**PSEG** Public Service  
Electric and Gas  
Company

October 1, 1984

HOPE CREEK GENERATING STATION  
DOCKET NO. 50-354  
REVISED DSER OPEN ITEM/QUESTION RESPONSES/FSAR TEXT

Question 430.33DSER Open Item No. 260 (DSER Section 8.3.3.3.5)THE USE OF A SINGLE BREAKER TRIPPED BY A LOCA SIGNAL AS AN ISOLATION DEVICE

FIGURE 430.33-1

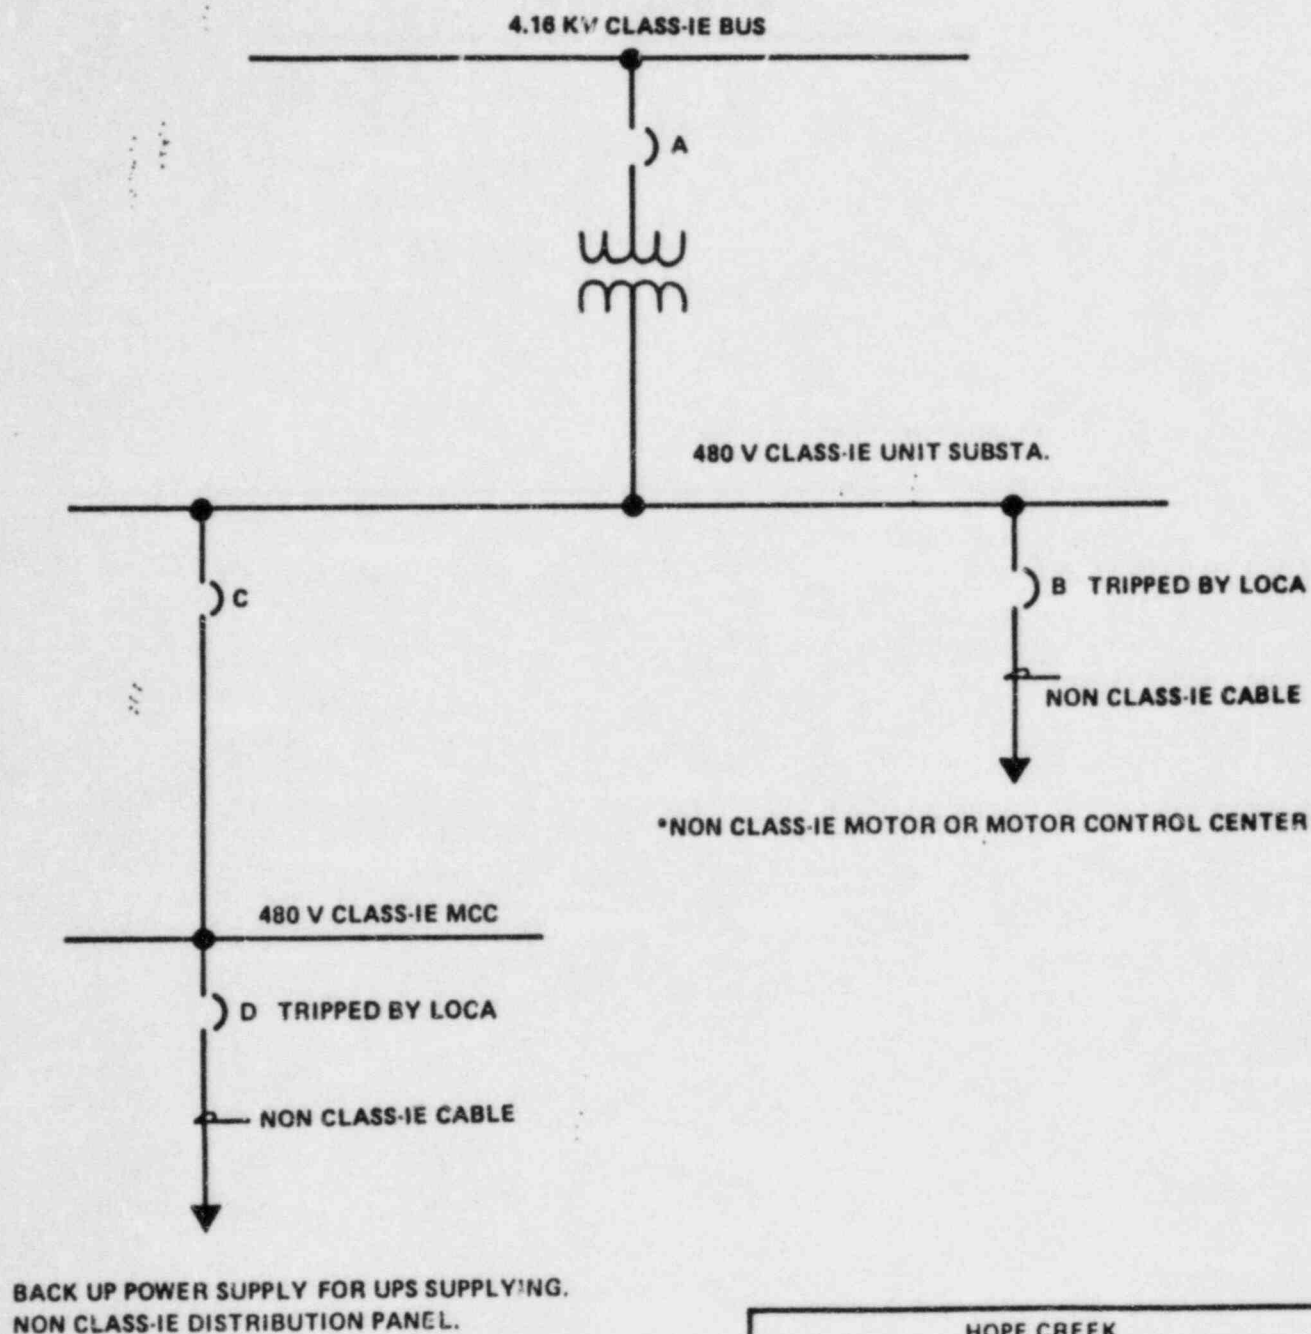
Section 8.3.1.1.2 of the FSAR indicates that the Class 1E system provides power to non-Class 1E loads. Non-Class 1E loads are connected to the Class 1E system through a single breaker that is tripped automatically by a LOCA signal. The single breaker tripped by a LOCA signal provides acceptable isolation between Class 1E and non-Class 1E circuits for the design basis accident--LOCA. However, for other design basis accidents or operating occurrences that do not generate a LOCA signal (such as loss of offsite power, design basis exposure fire, seismic events, etc.), it is the staff concern that a single breaker may not provide acceptable isolation.

By Amendment 4 to the FSAR, the applicant indicated that protective device coordination studies show that the single breaker time overcurrent trip characteristics will trip to clear a fault prior to initiation of a trip of a upstream breaker. Identification of all non-Class 1E circuits being isolated using a single breaker trip by LOCA signal, periodic testing of breaker coordination, and capability of breaker to trip prior to any versus only upstream breaker and for all versus only circuit faults, will be pursued with the applicant.

Section 8.3.1.1.2 of the FSAR indicates that the Class 1E system provides power to non-Class 1E loads. Non-Class 1E loads are connected to the Class 1E system through a single breaker that is tripped automatically by a LOCA signal. The single breaker tripped by a LOCA signal provides acceptable isolation between Class 1E and Non-Class 1E circuits for the design basis accident - LOCA. However, for other design basis accidents or operating occurrences that do not generate a LOCA signal (such as loss of offsite power, design basis exposure fire, seismic events, etc), it is the staff concern that a single breaker may not provide acceptable isolation. Provide an analysis, in accordance with the guidelines of Section 4.9 of IEEE Standard 308-1974, that demonstrates that failure of anyone or simultaneous combined failure of all non Class 1E loads will not prevent any of the four channels of Class 1E power from performing its safety function. The analysis should consider, but not be limited to, (1) capacity and capability of onsite and offsite power supplies and their associated distribution system to supply power to Class 1E loads within their design ratings for all modes of plant operation, (2) the guidelines of Section 7.1.2.1 of IEEE standard 384-1981, (3) an analysis of diesel generator loadings for loss of offsite power similar to that presented in Tables 8.3-2 through 8.3-6 of the FSAR, (4) the failure of the Non Class 1E dc system that supplies control power to the subject non Class 1E loads, and (5) a similar analysis of the Class 1E dc system if non-Class 1E loads are connected.

Figure 430.33-1 shows the two configurations that employ a circuit breaker tripped by a LOCA signal as an isolation device. The two configurations are:

Protective device coordination studies for devices shown in Figure 430.33-1 have shown that the time-overcurrent trip characteristics of circuit breakers A, B, C, and D are such that:

- a. Circuit breaker B will trip to clear a fault current prior to initiation of a trip of circuit breaker A.
- b. Circuit breaker D will trip to clear a fault current prior to initiation of a trip of circuit breaker C.

Periodic testing of the breaker time-overcurrent trip characteristics will be performed to demonstrate that the circuit breaker trip function remains within required limits. Table 430.33-1 identifies the non-Class 1E loads that are supplied through circuit breakers B and D of Figure 430.33-1.
